JERSEY CENTRAL POWER & LIGHT COMPANY

OYSTER CREEK NUCLEAR GENERATING STATION, UNIT NO. 1

AMENDMENT TO PROVISIONAL OPERATING LICENSE

Amendment No. 46
License No. DPR-16

FIGURE 3.5-1

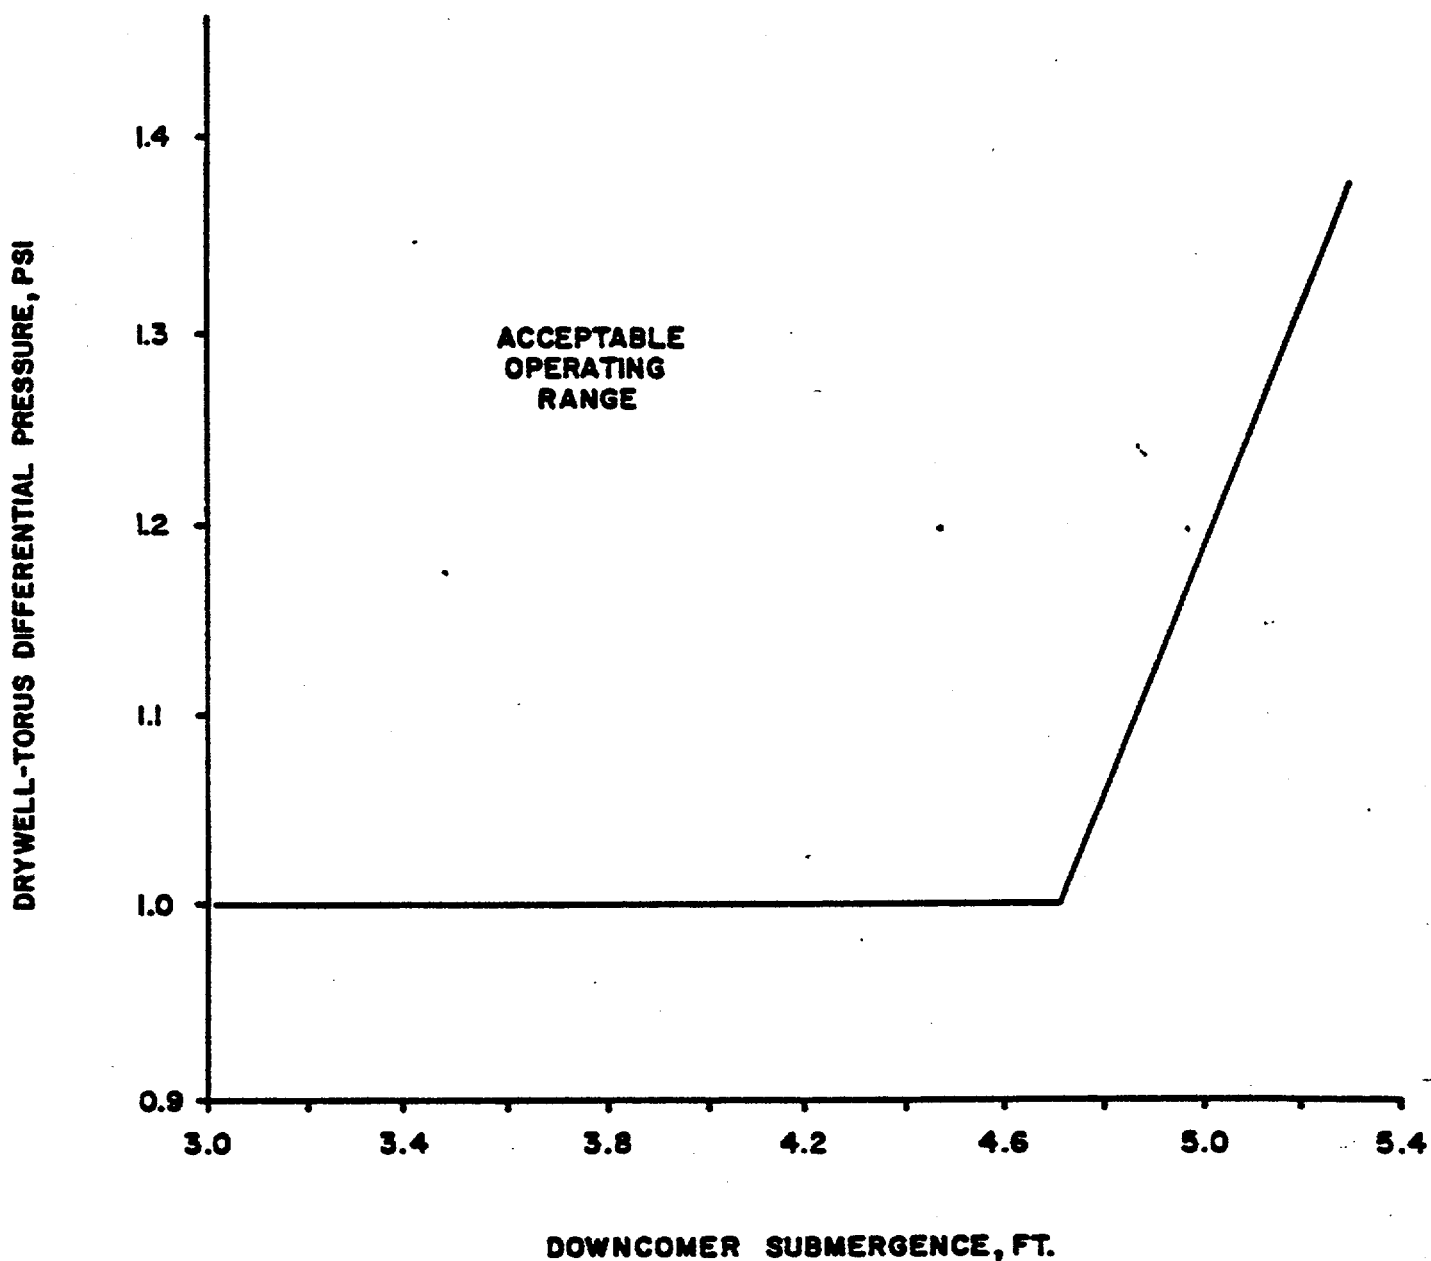
This amendment allows a minimum suppression chamber downcomer submergence of three feet and is a result of the Mark I Containment Long Term Program.

Replace the following pages of the Appendix "A" Technical Specifications with the enclosed pages. The revised pages are identified by the captioned amendment number and contain vertical lines indicating the area of change.

*The actual acceptable range of downcomer submergence is governed by the Technical Specifications limit on maximum and minimum water volume in the torus (see section 3.5.A.1). This actual acceptable range of downcomer submergence will not encompass the full range of downcomer submergence indicated in the figure above.
